Technical Service Bulletin: TSB150113

New Fuel Pump with Diamond-Like Coated Tappet Roller Pin

Figure 1, (A) Obsolete Brass Tappet Roller Pin (B) New Diamond-Like Coated Tappet Roller Pin

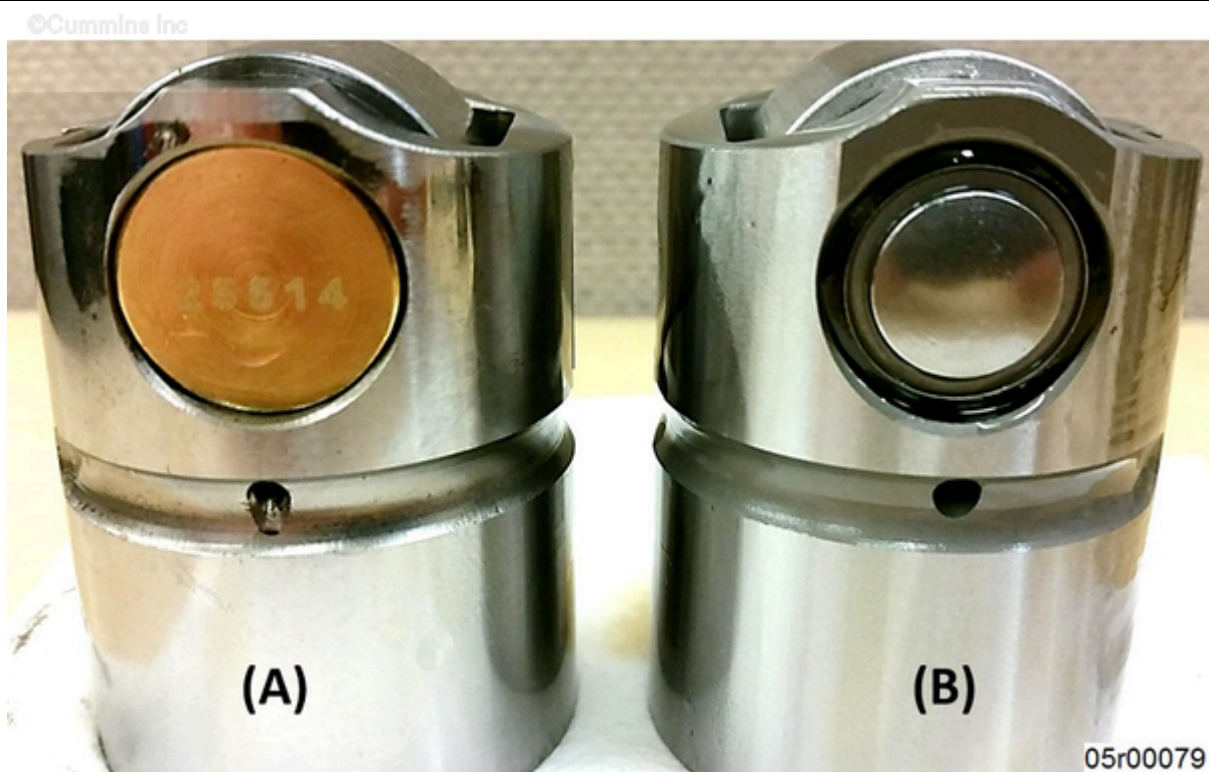
Fuel pump assembly part numbers with brass tappet roller pins are being obsoleted and superseded by fuel pump assemblies with diamond-like coated tappet roller pins, see Figure 1 below.

The diamond-like coated tappet roller pins are less susceptible to debris or corrosion damage, which can lead to a fuel pump failure.
